Subject: AP1000 Response to Request for Additional Information (SRP 9)

RAI-SRP 9.1.2-SEB1-06 R3

# AP1000 TECHNICAL REPORT REVIEW

RAI Response Number: RAI-SRP 9.1.2-SEB1-06  
Revision: 3

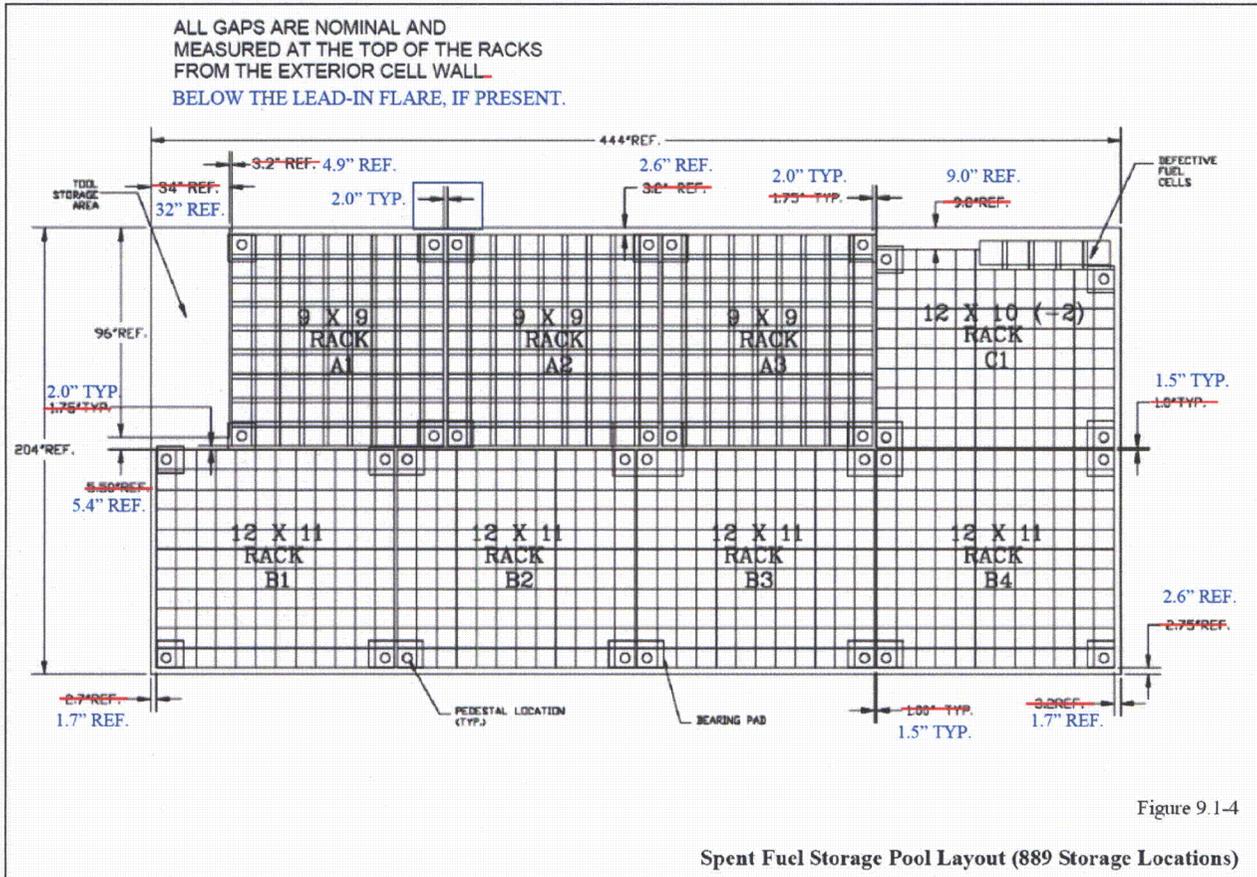
- The placement of the racks within the spent fuel pool is being modified to account for the aforementioned changes and to optimize the gaps such that the impacts (both rack-to-rack and rack-to-wall) are minimized. The slightly modified pool layout is shown in the markup of DCD Figure 9.1-4 on the following page.

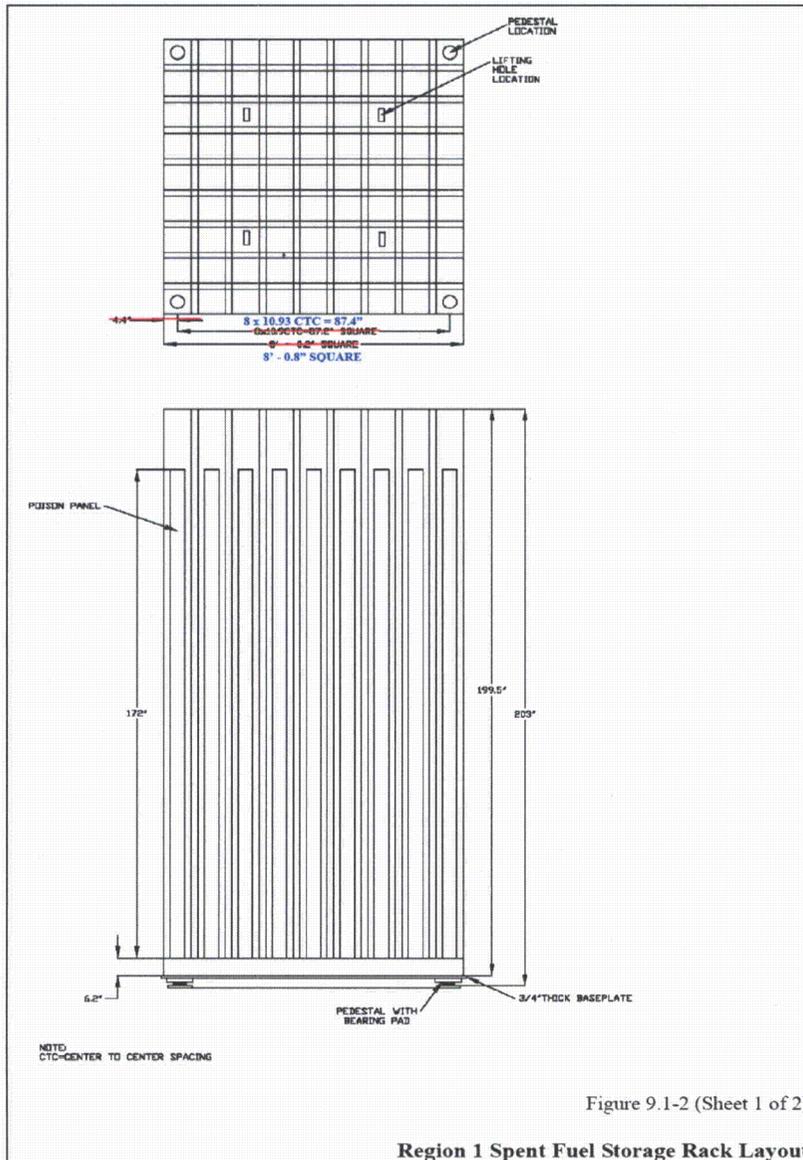
- Figure 9.1-2 (Sheet 1 of 2) of Rev. 17 of the DCD should be modified as follows:
  - The 4.4" dimension should be deleted, as it can be calculated from the other 2 dimensions provided, and it is inconsistent with the format of Figure 9.1-3.
  - $8 \times 10.9 \text{ CTC} = 87.2" \text{ SQUARE}$  should be changed to  $8 \times 10.93 \text{ CTC} = 87.4" \text{ SQUARE}$
  - $8' - 0.2" \text{ SQUARE}$  should be changed to  $8' - 0.8" \text{ SQUARE}$

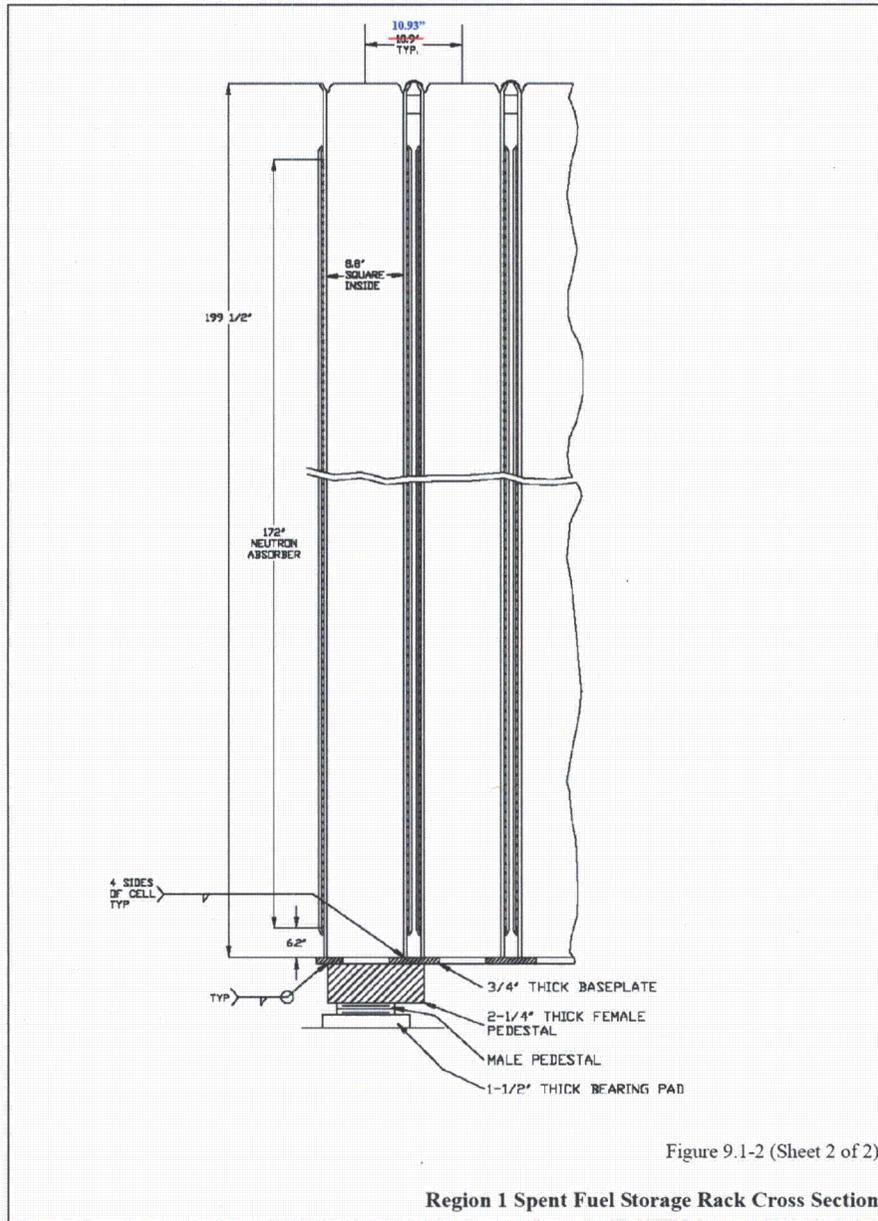
- Figure 9.1-2 (Sheet 2 of 2) of Rev. 17 of the DCD should be modified as follows:
  - 10.9" TYP. should be changed to 10.93" TYP.

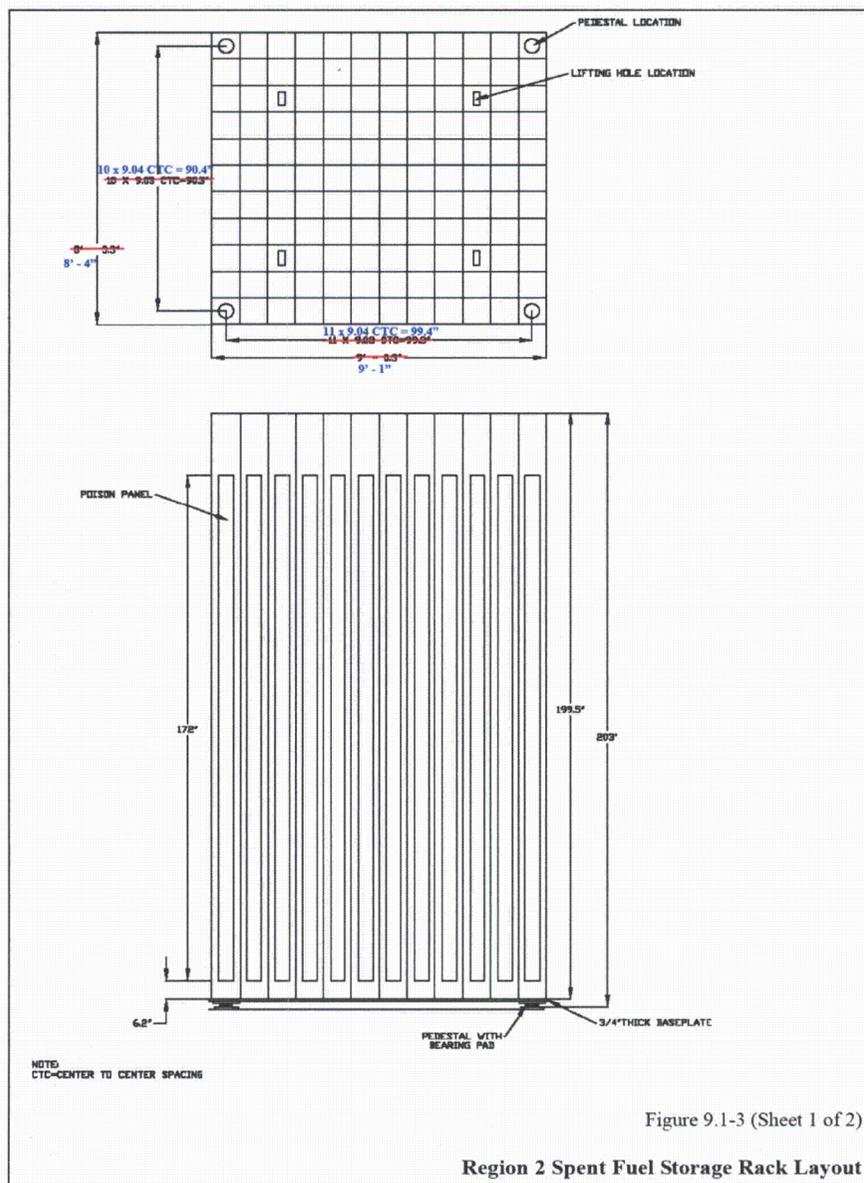
- Figure 9.1-3 (Sheet 1 of 2) of Rev. 17 of the DCD should be modified as follows:
  - 10 x 9.03 CTC=90.3" should be changed to 10 x 9.04 CTC = 90.4"
  - 8' - 3.3" should be changed to 8' - 4"
  - 11 x 9.03 CTC=99.3" should be changed to 11 x 9.04 CTC = 99.4"
  - 9' - 0.3" should be changed to 9' - 1"

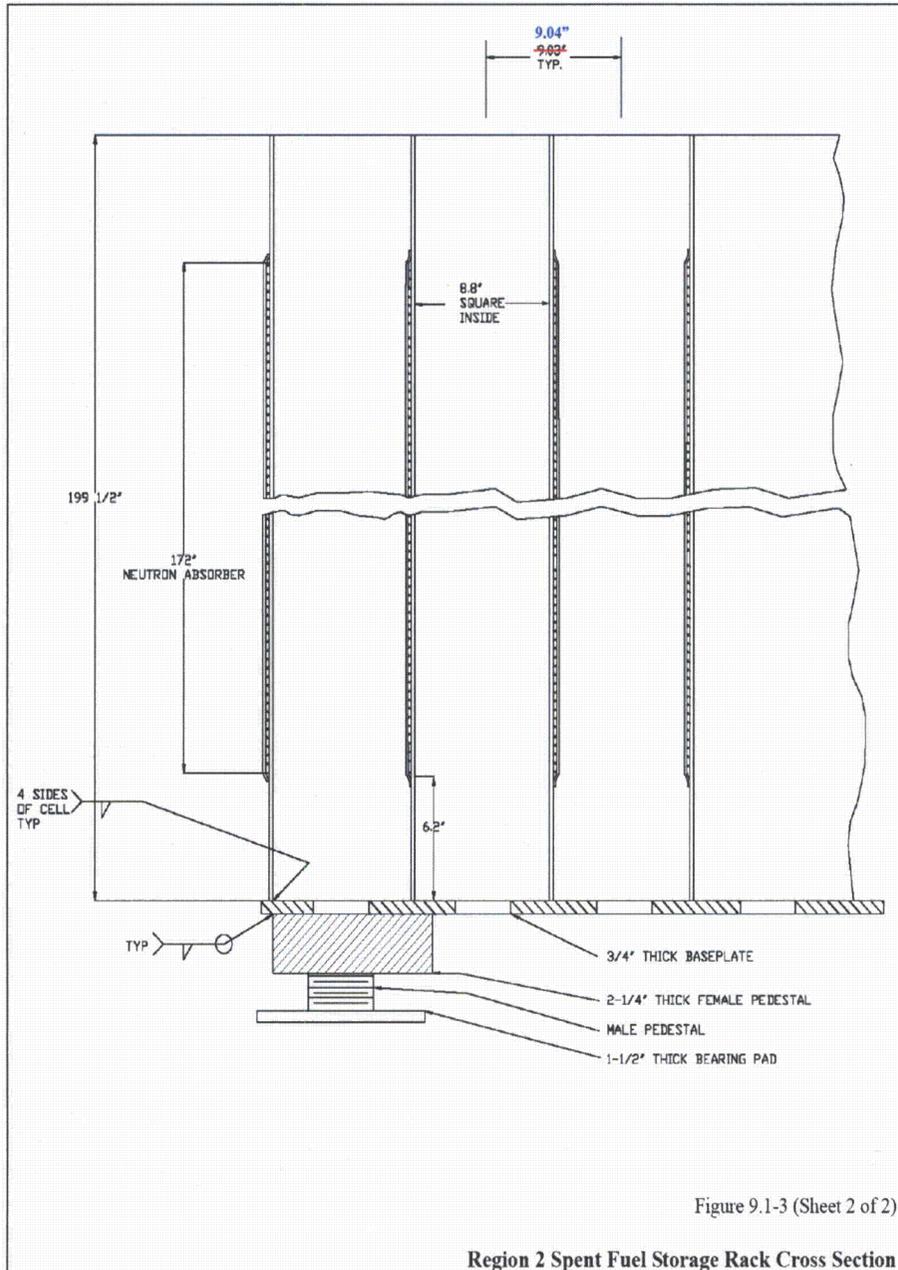
- Figure 9.1-3 (Sheet 2 of 2) of Rev. 17 of the DCD should be modified as follows:
  - 9.03" TYP. should be changed to 9.04" TYP.

**Figure RAI-SRP9.1.2-SEB1-06-01: Node/Element Number and Applied Load**

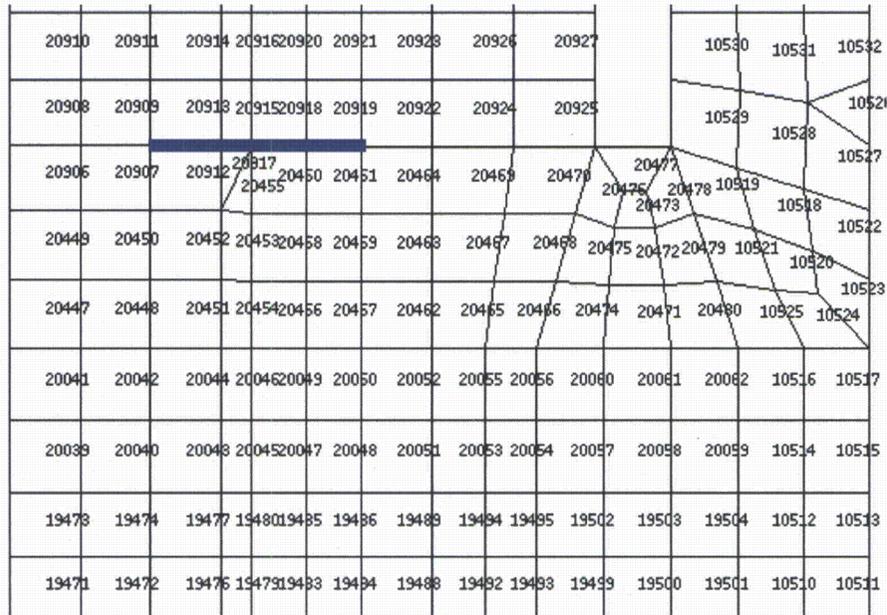
**Item 2.** Westinghouse will determine the element member forces at several critical locations on wall L-2 for both the load combination with seismic only and by adding the rack impact to the seismic load combination. A comparison between the two cases will be provided.

Item 2. The element member forces at several critical locations on wall L-2 for load combinations 2 and 15 were evaluated with and without rack impact loading. Table RAI-SRP9.1.2-SEB1-06-03 provides results of the effect of rack loads on element forces for an impact load of 363 kips. Elements 20450 and 20451 are in the vicinity of the applied rack loads as shown in Figure RAI-SRP9.1.2-SEB1-06-1. Element 10529 is further away from rack load locations as shown in Figure RAI-SRP9.1.2-SEB1-06-2. The plate thickness is adequate to withstand this impact load. It is noted that the hydrostatic pressure is included in the load combinations.

**Figure RAI-SRP9.1.2-SEB1-06-02: Node/Element Number**

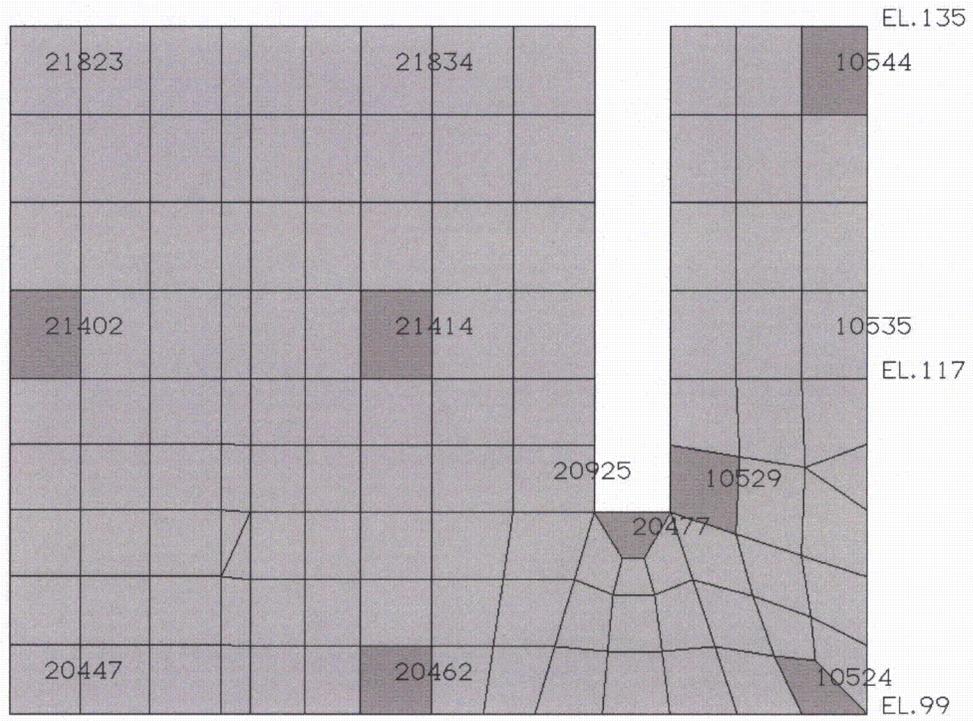
**Item 1.** Westinghouse will calculate the third principal stress in the surface faceplate and determine the tri-axial state of stress in the surface faceplate. The first two principal stresses will be obtained from the shell stresses of the NI05 model. The third principal stress will be obtained by hand calculation in which the impact force will be spread over a contact surface.

The calculation results are provided in Table RAI-SRP9.1.2-SEB1-06-02 for the effect of the tri-axial state of stress in the faceplate of wall L-2 for element 10529 with load combination 15 and for elements 20450 and 20451 with load combination 2. The table compares the tri-axial stress state with and without rack impact loading. Tables RAI-SRP9.1.2-SEB1-06-01 and RAI-SRP9.1.2-SEB1-06-02 show that the effect of tri-axial state of stress is dependent on the stress level of the faceplate.
